# LAKE ONTARIO SHORELINE HAZARD SUMMARY, RISK ASSESSMENT AND MANAGEMENT PLAN

## TECHNICAL REPORT

DATE: 2022-05-09

APPENDIX E – PUBLIC FEEDBACK ON DRAFT REPORT AND RESPONSES FROM PROJECT TEAM

Figure 16 – Typical multi-layer, irregular armour stone or field stone revetment concept for low bank shoreline

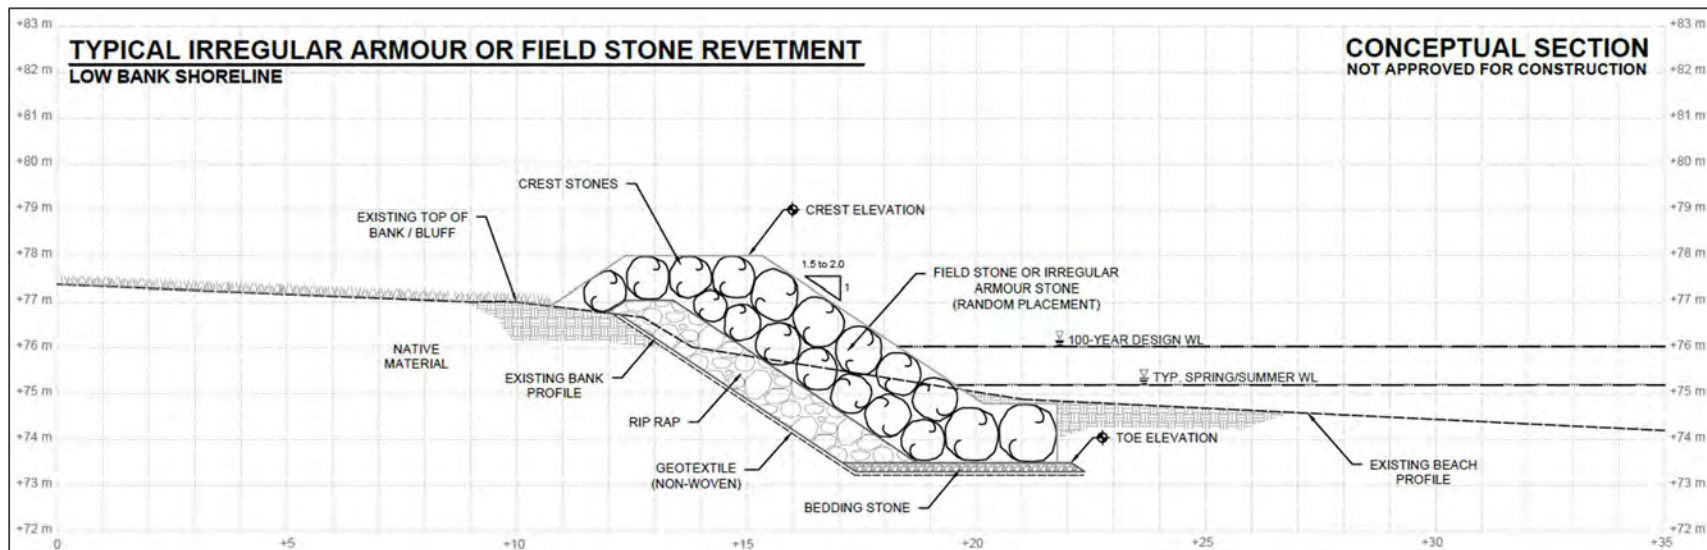
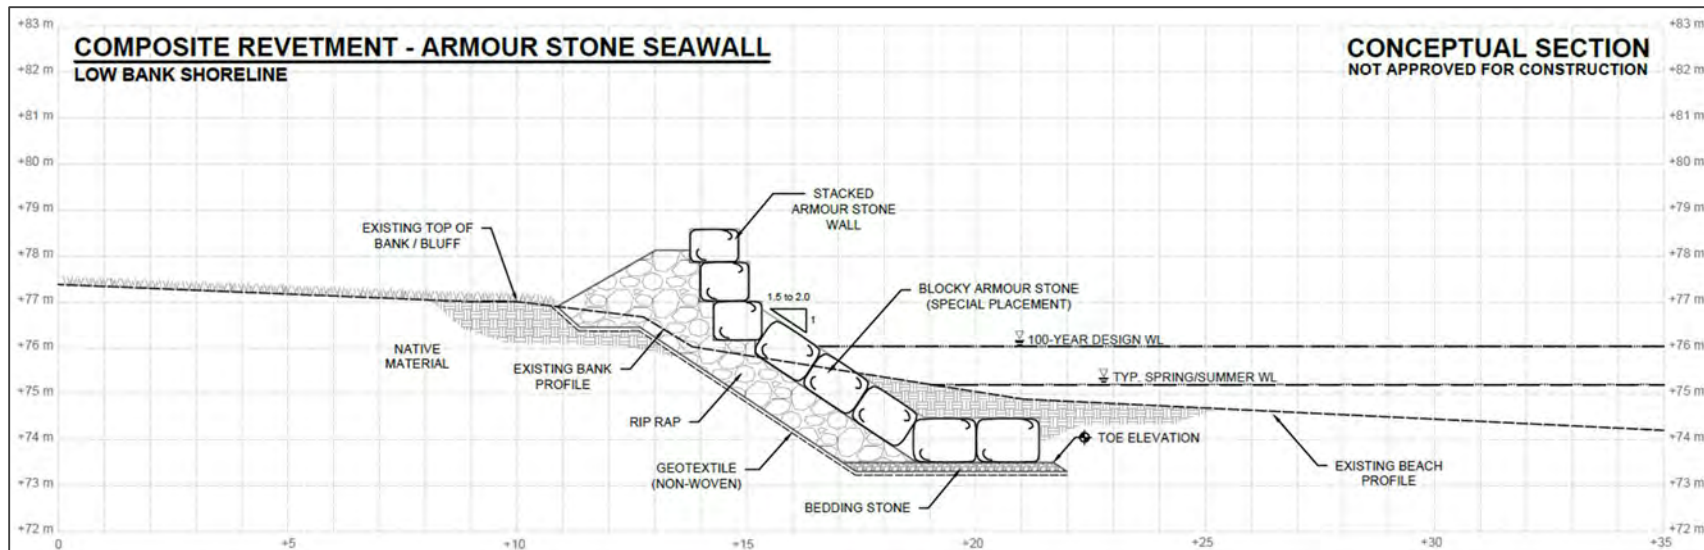
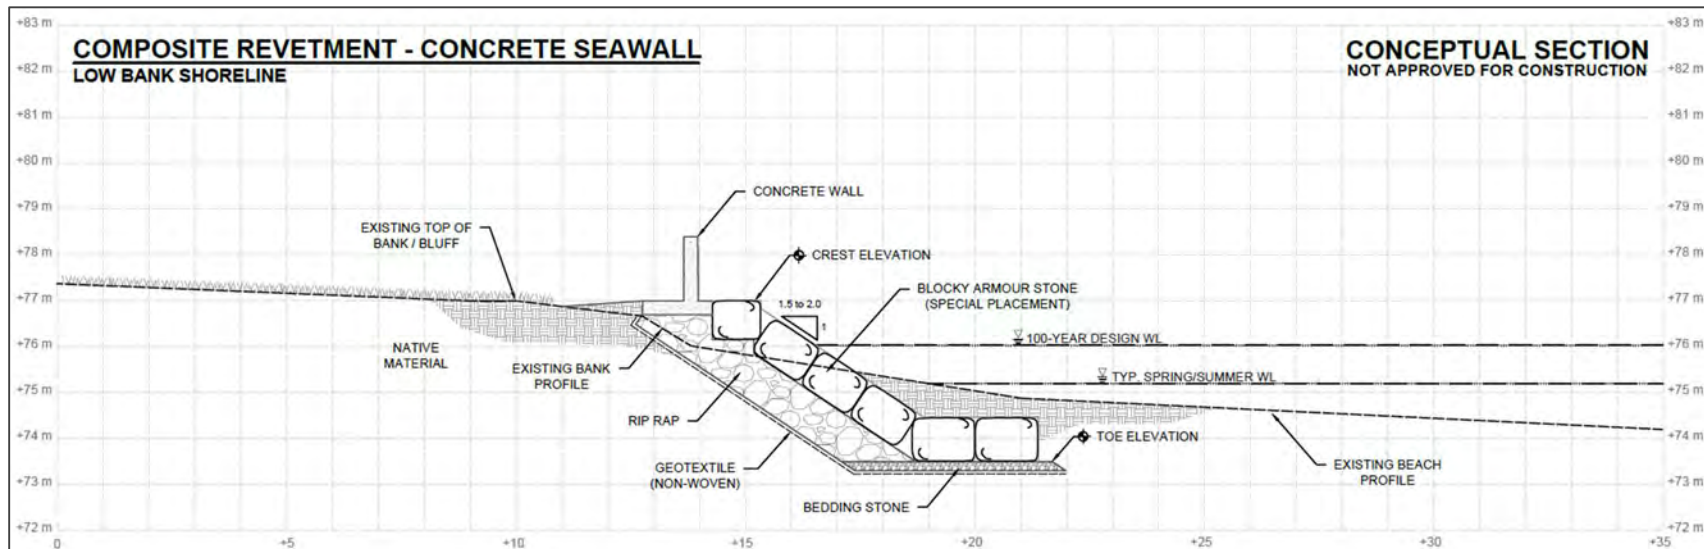
29. Figure 16 – 18 represent conditions where the revetments are built higher than the native grades inland. When these designs were built along SDC #5 Port Darlington they have resulted in significant flooding partially due to the splash zone from incoming waves overtopping the shoreline and secondly by the inability of the overtopped water to return to the lake efficiently and continually build up. I have witnessed this extensively where the splash will rise easily over 20 feet high and land well onto properties beyond.

30. Figure 16 – 18. There would be significant overtopping and seepage through the top armoring during a sustained storm when waves that break almost on the shore build up significantly when compressed and **add to the reflected waves**. Designs that create reflected waves rather than dissipate wave energies like a natural beach does, actually create even more problems.
